Kingfisher Pond - Northstowe Hydrogeological Assessment

Baseline Conceptual Report

FWM8714-RT001-R03-00

D. Review of Phase 1 Report

Figure 2.1: Solid and drift geological map of Huntington (187) and Cambridge (188)

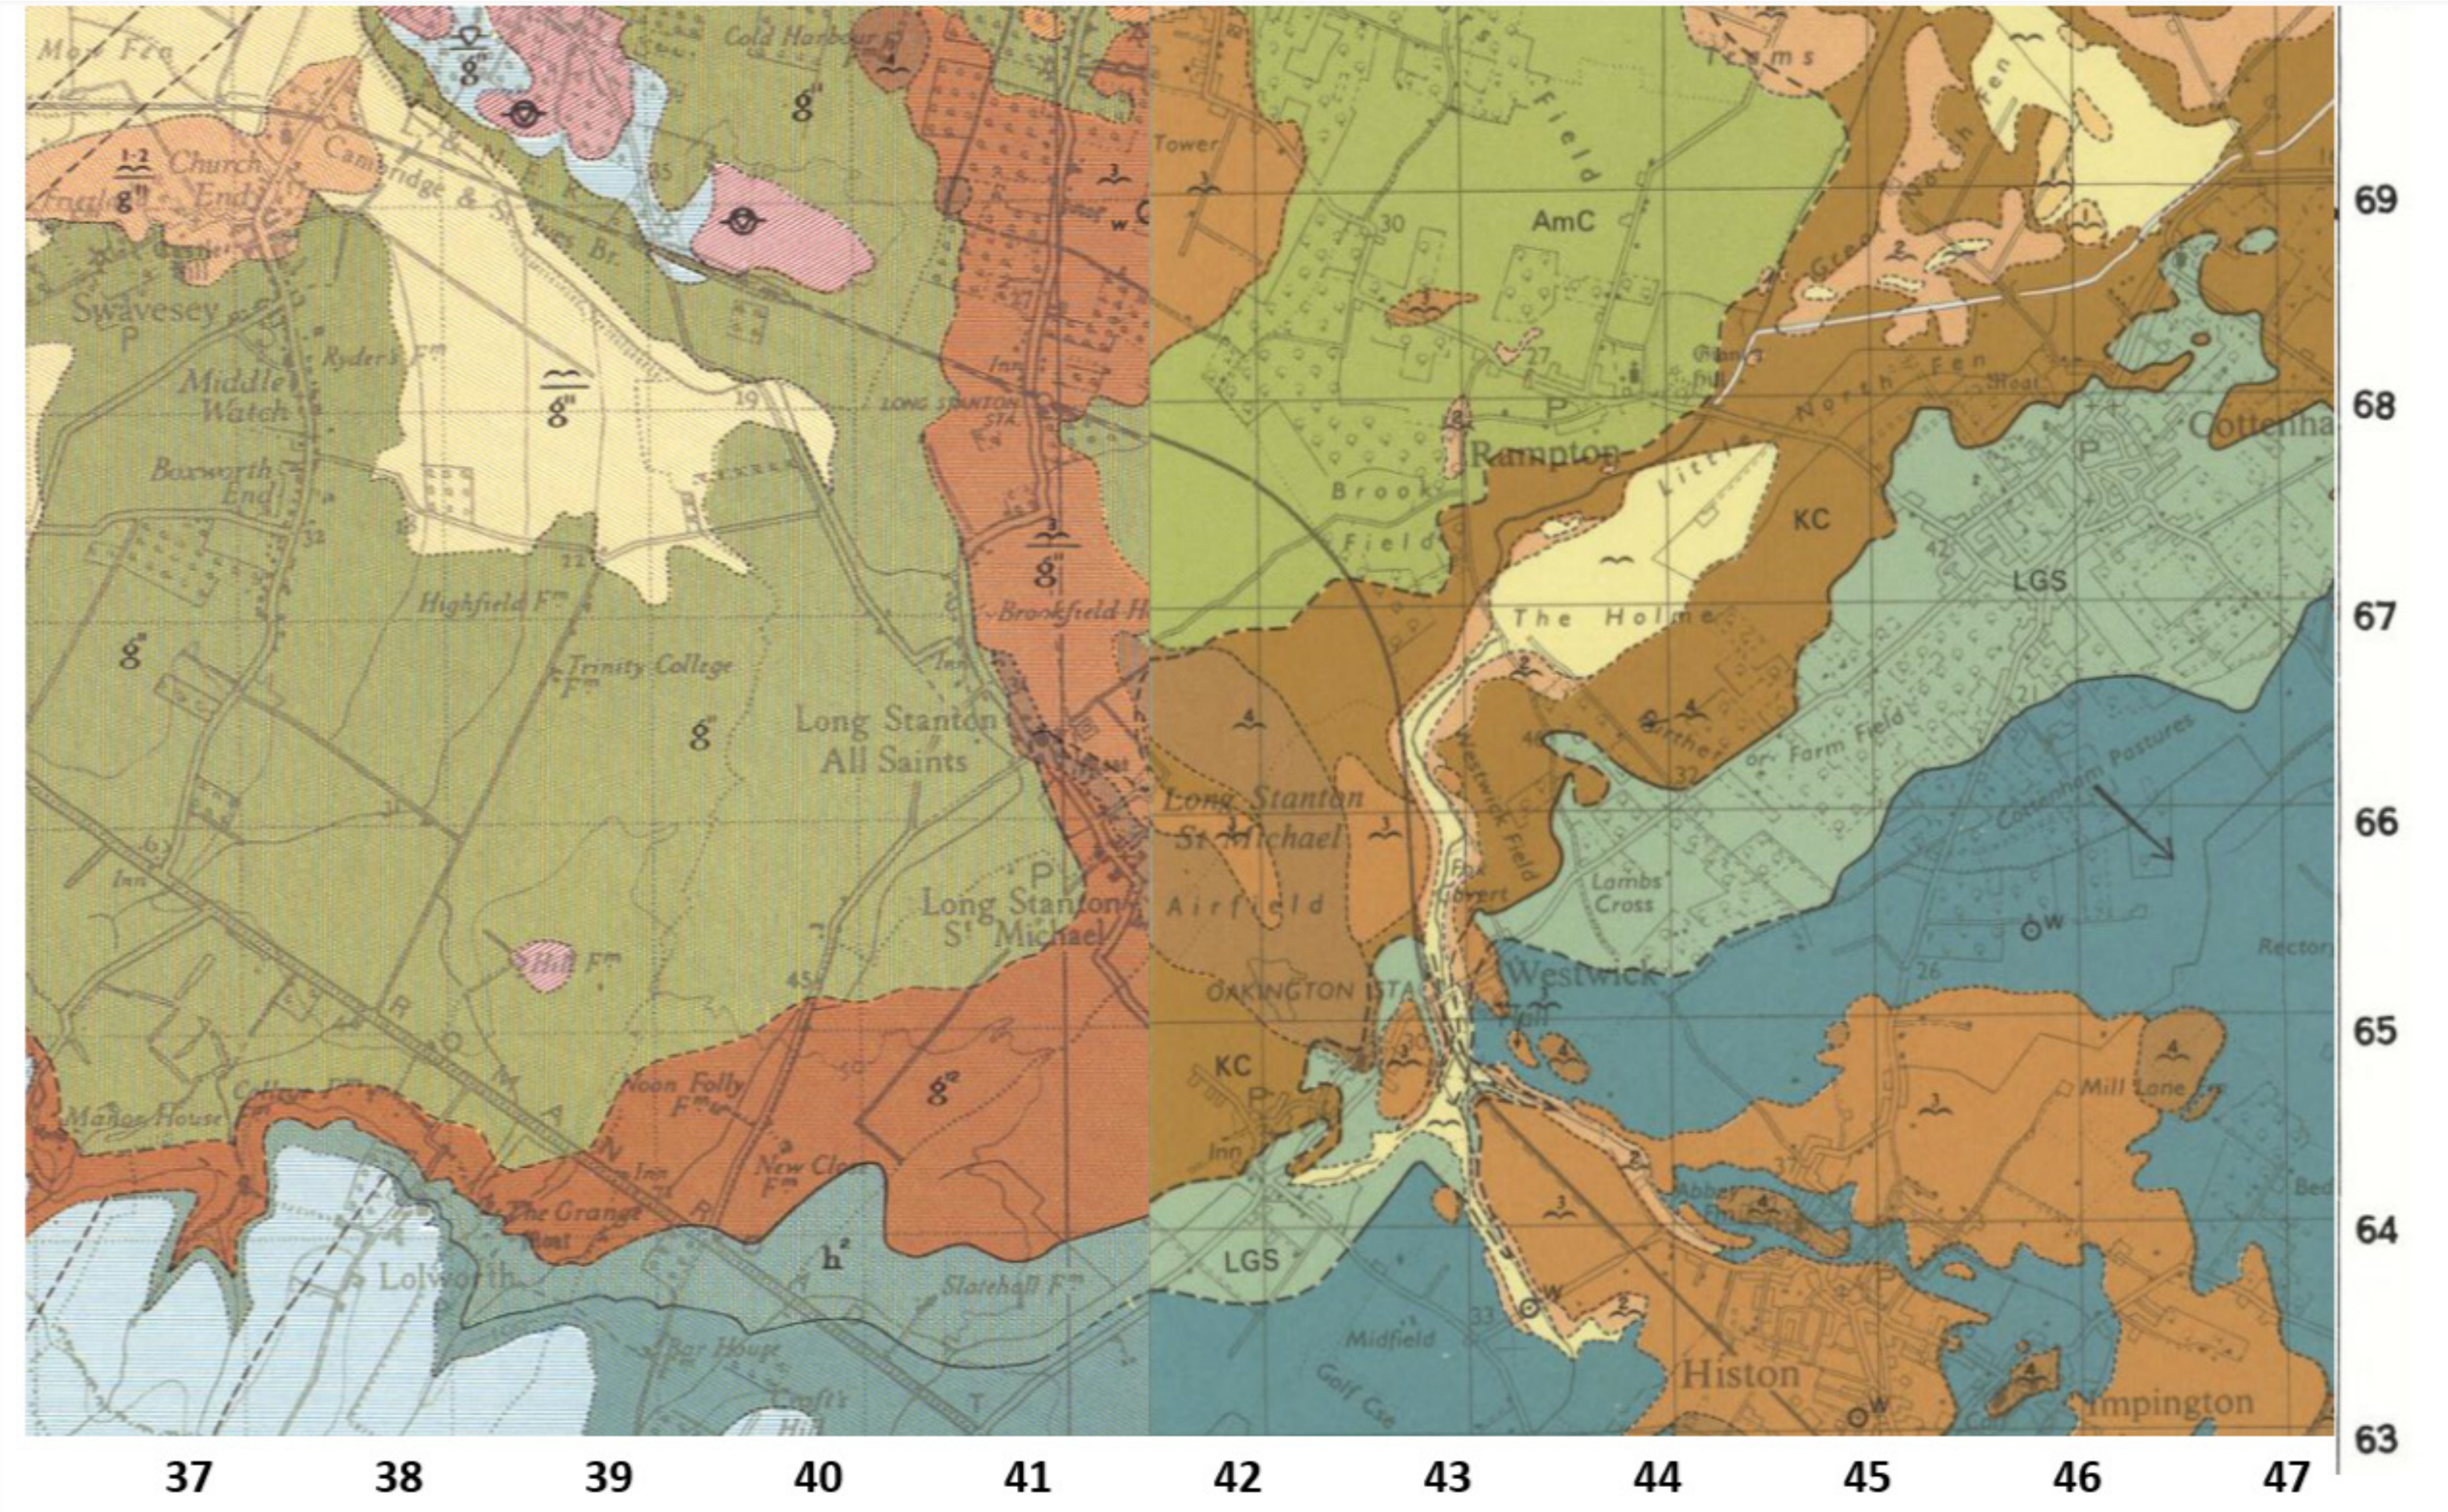
Figure 2.1 Solid and drift Geological Map of Huntingdon (187) and Cambridge (188) shows clearly the extent to which large parts of Longstanton lie on the gravel deposits. This map shows clearly that both churches lie within this area as does the entire Longstanton conservation area.

Figure 4.3: Map highlighting locations of boreholes of interest at Northstowe Phase 1

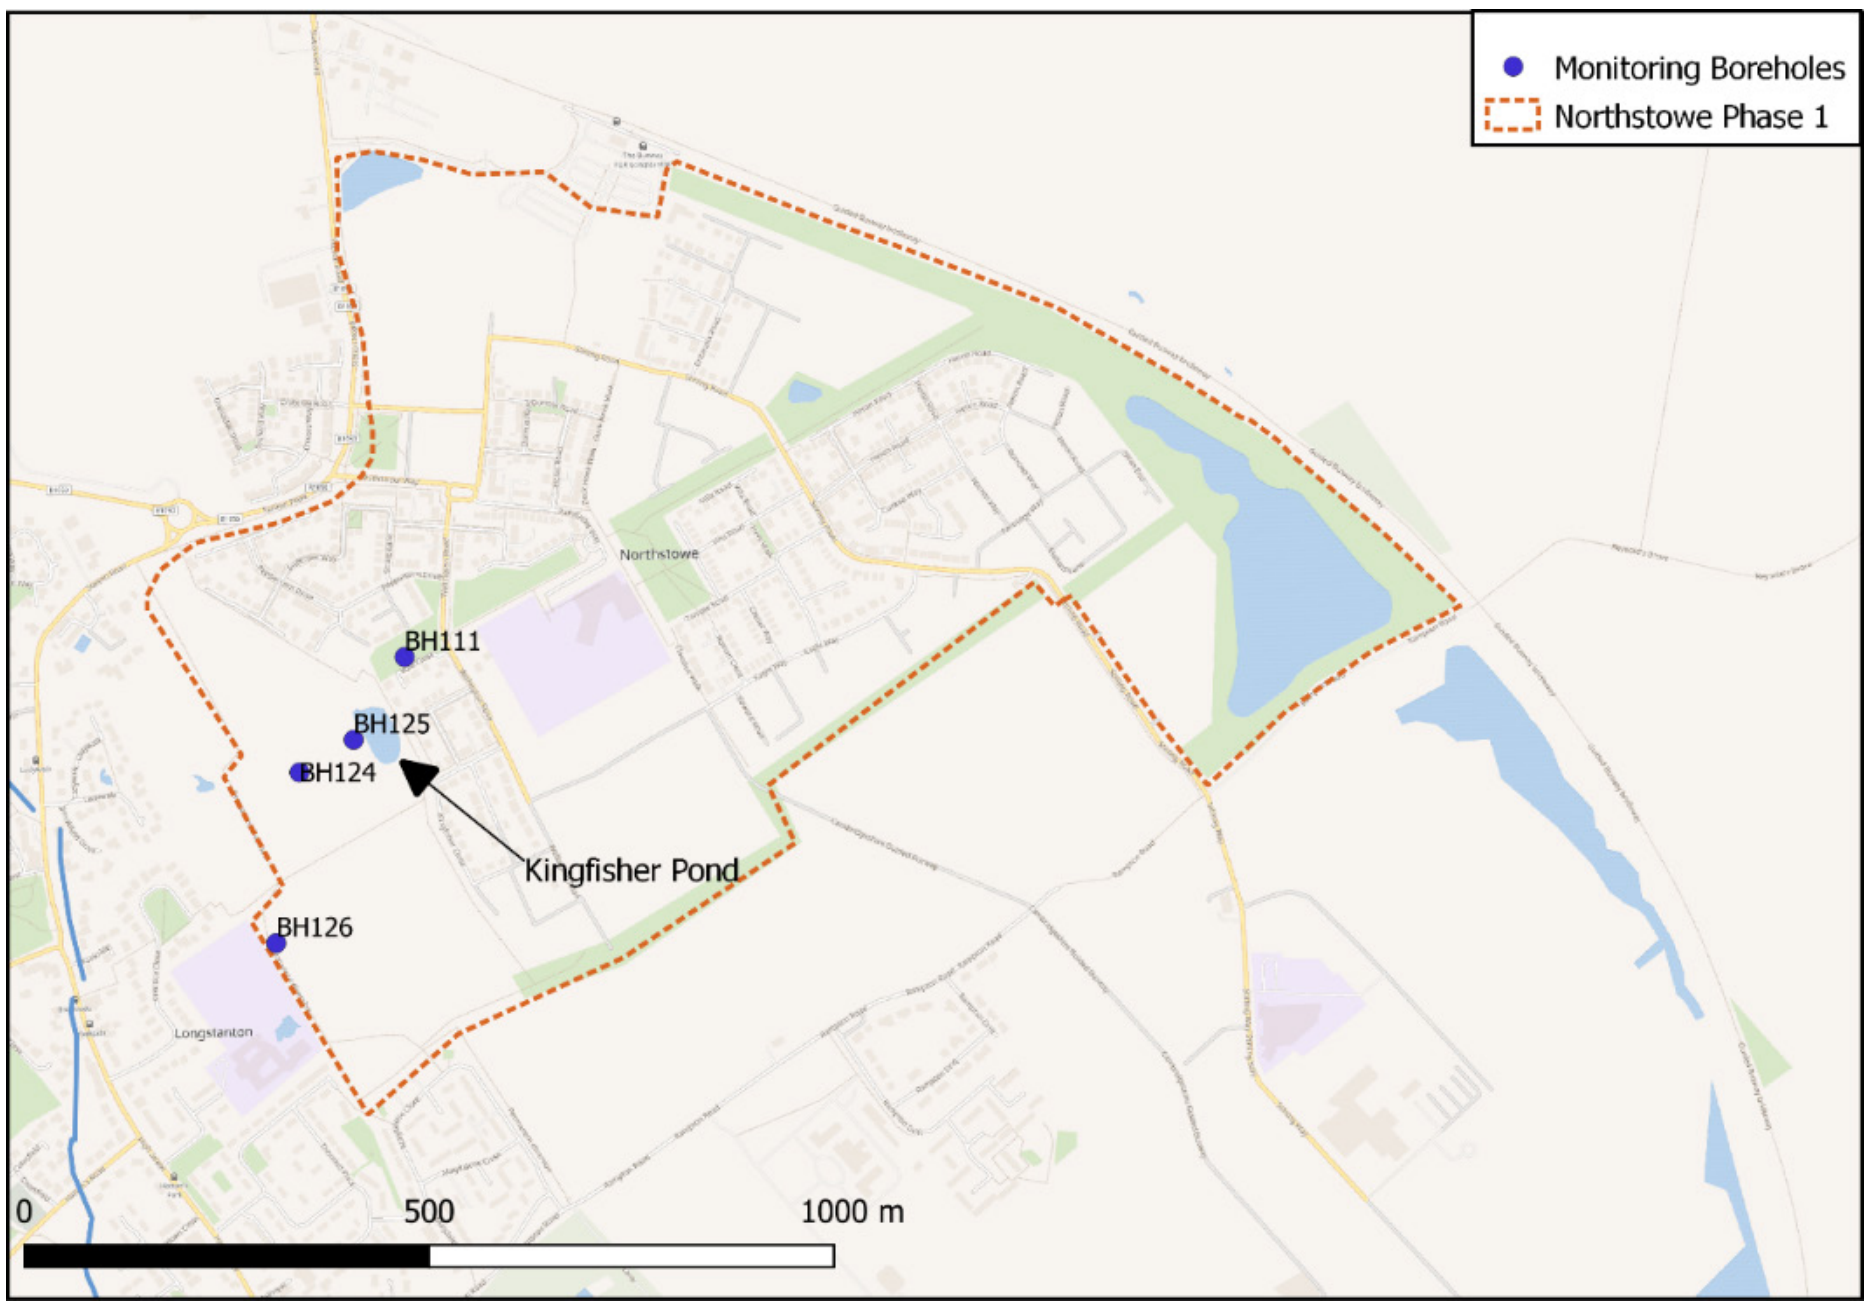
The report mentions boreholes of interest and provides a map showing some boreholes on Phase 1. Due to the known hydraulic connectivity of the RTD (which would have been known prior to planning permission being granted), this report makes no mention of any bore holes being monitored off site elsewhere across Longstanton and the gravels. The report does not make clear whether off site monitoring of the groundwater levels in the RTD was being carried out and whether it was a requirement of the planning permission. With the presence of a multitude of lakes and ponds along the RTD, in addition to the wells, the Listed churches, a Listed Manor House, the entire Longstanton conservation area and trees with Tree Preservation Orders on them – it seems that not making this clear is an oversight. Indeed, should the original planning permission have contained safeguards to protect the ponds, wells, buildings and conservation area from possible damage due to works being carried out on the RTD? I would have thought that there was a statutory obligation on SCDC to monitor Northstowe works and protect Longstanton's Listed buildings, the conservation area and TPO trees from being damaged by the Northstowe development. This clearly is an issue that needs to be addressed in the next report. The hydraulic connectivity of the groundwater in the RTD is the key to understanding why such extensive damage has been recorded across Longstanton. Once again, HR Wallingford cannot be responsible for the limited scope of this report but the limited scope should not restrict discussion on the wider potential impacts of the reduction in the groundwater, and the vulnerabilities and consequences to Longstanton property of a catastrophic collapse.

Photograph 7.1: Kingfisher Pond, 20 April 2014

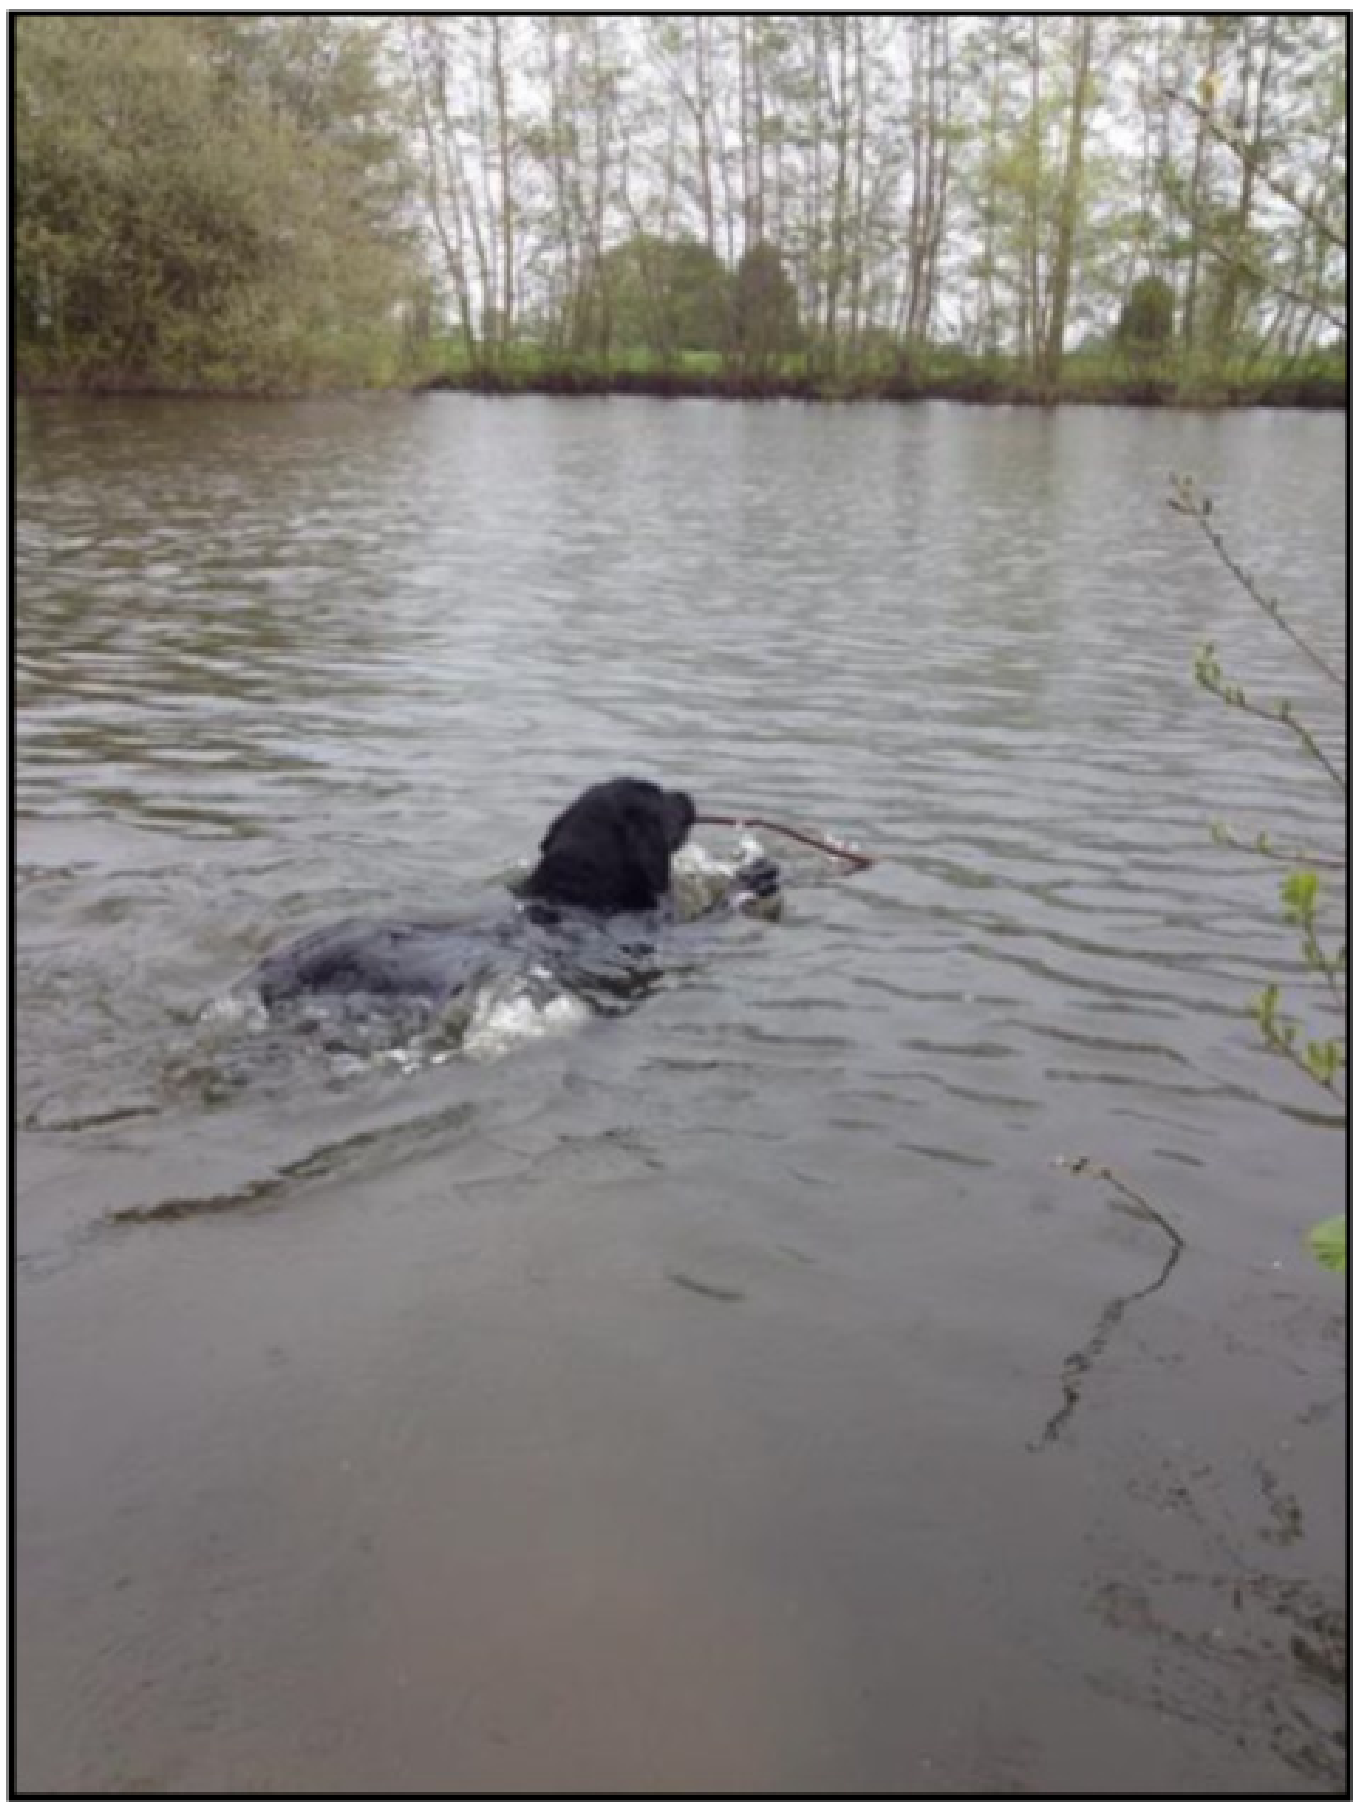
An example of seriousness of residents' concerns can be seen by the following photographs. These photographs do relate specifically to the Kingfisher Pond but residents also collated evidence on the deterioration of the other ponds and wells in Longstanton. This evidence was shared in a timely manner from early 2016 onwards with the developer, SCDC planners and local councillors. In view of the depth of evidence that had been supplied to SCDC there can be no excuse for the decision to allow the remit of HR Wallingford's investigations to be restricted to the Kingfisher Pond alone.

Photo left: Kingfisher Pond, 20 April 2014

Photo below: Kingfisher Pond, 26 December 2017
